Illinois Department of Transportation

SUBJECT: MidAmerica St. Louis Airport
Mascoutah, Illinois
St. Clair County
Illinois Project Number: BLV-5101
AIP Project Number: 3-17-0146-TBD
Contract No. SC071
Item No. 12A, June 16, 2023 Letting
Addendum A

NOTICE TO PROSPECTIVE BIDDERS

TERMINAL APRON EXPANSION -
PROJECT 1

SHEET 57 OF 60
CG707

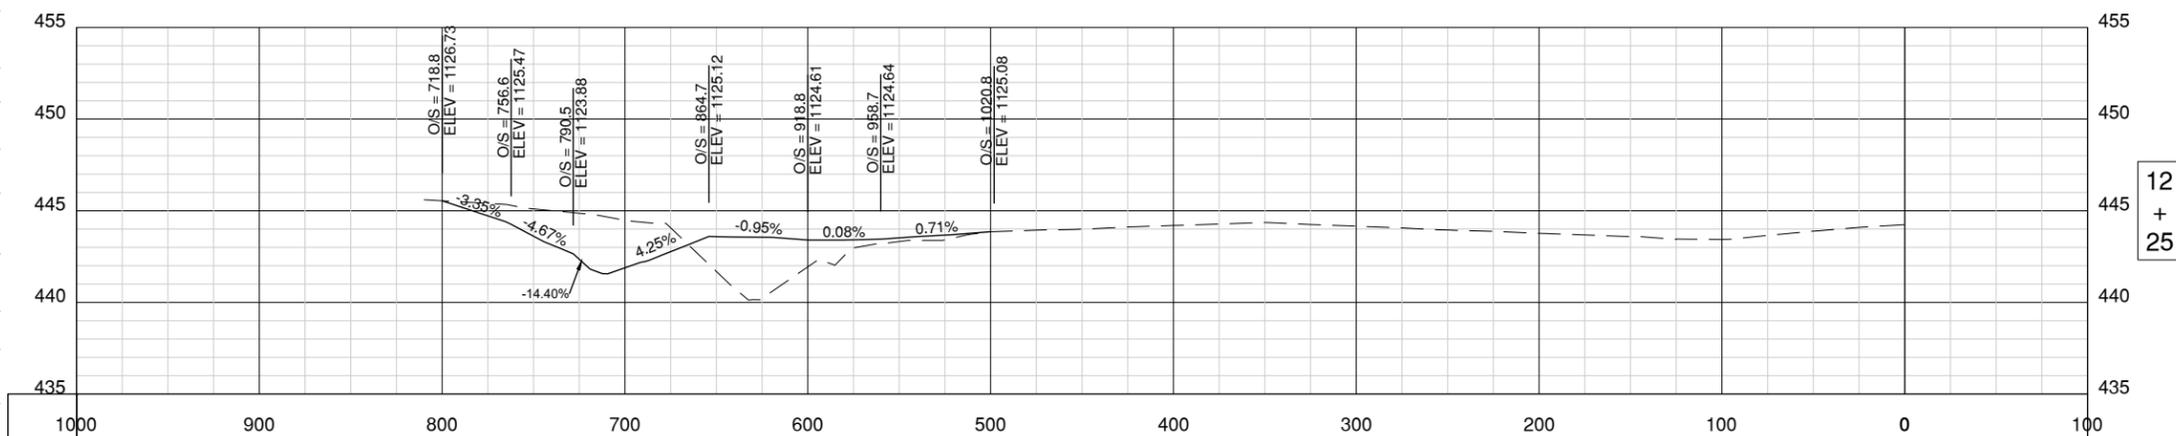
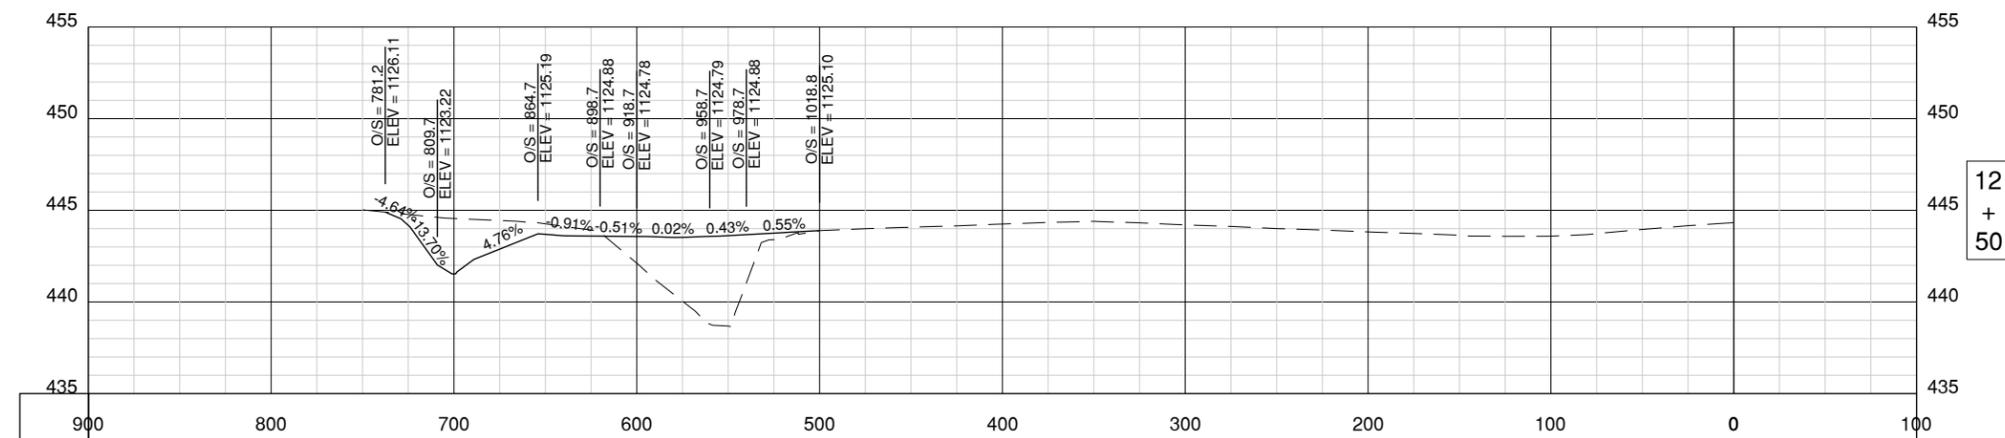
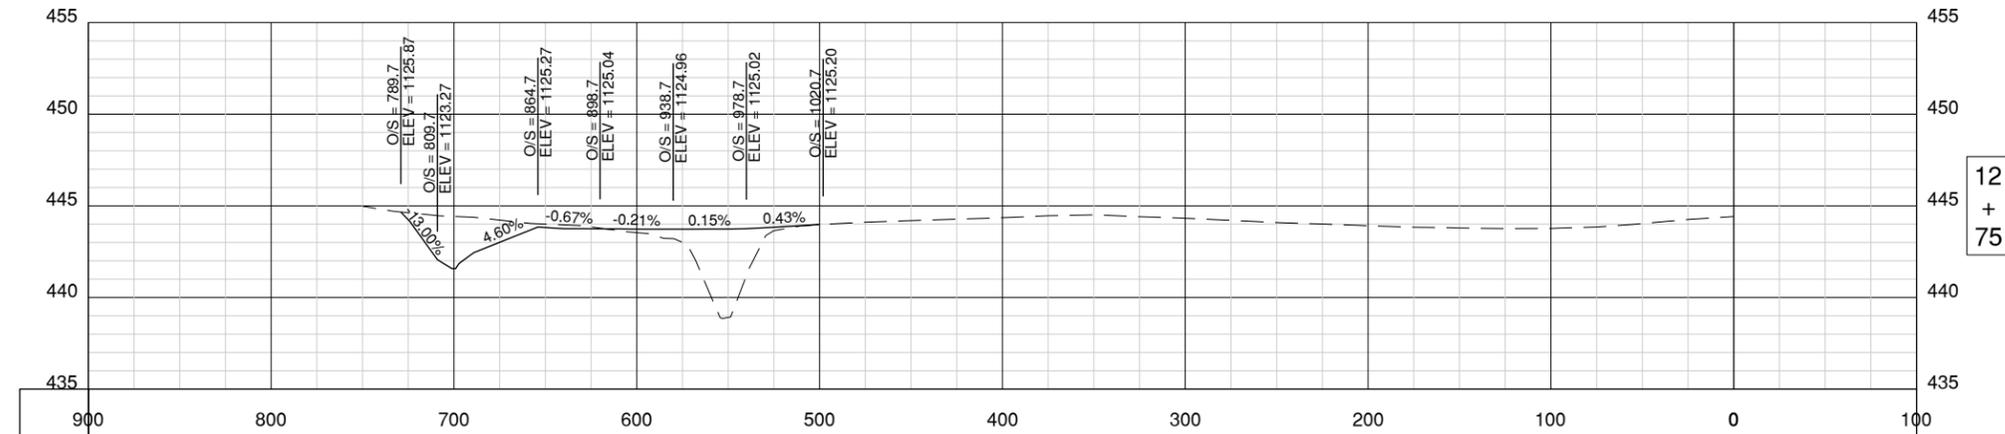
14. Clarify notes on Plan Sheet CG506
15. Update cross sections on Plan Sheets CG706-710
16. Clarify Item SP-3 Sanitary Sewer Installation, Section 3-1.4 Project Conditions

- Sheet GI102
 - Updated to add pay items AW801455 and AW801958.
- Sheet GI103
 - Updated to add pay items AW801455 and AW801958.
- Sheet GC101
 - Updated to show access roads are now pay items AW801455 and AW801958.
- Sheet GC102
 - Updated to show access roads are now pay items AW801455 and AW801958.
- Sheet GC103
 - Updated to show access roads are now pay items AW801455 and AW801958.
- Sheet CI101
 - Updated grades and profile for the service road.
- Sheet CP801
 - Updated staking elevations.
- Sheet CG101
 - Updated contours and structure rim elevations.
- Sheet CG301
 - Updated profile elevations
- Sheet CG302
 - Updated profile elevations
- Sheet CG303
 - Updated profile elevations
- Sheet CG501
 - Add sheet to plan set
- Sheet CG502
 - Add updated plan sheet to plan set
- Sheet CG506
 - Revise call offs on Detail "Part Section A-A"
- Sheet CG706-710
 - Updated cross sections
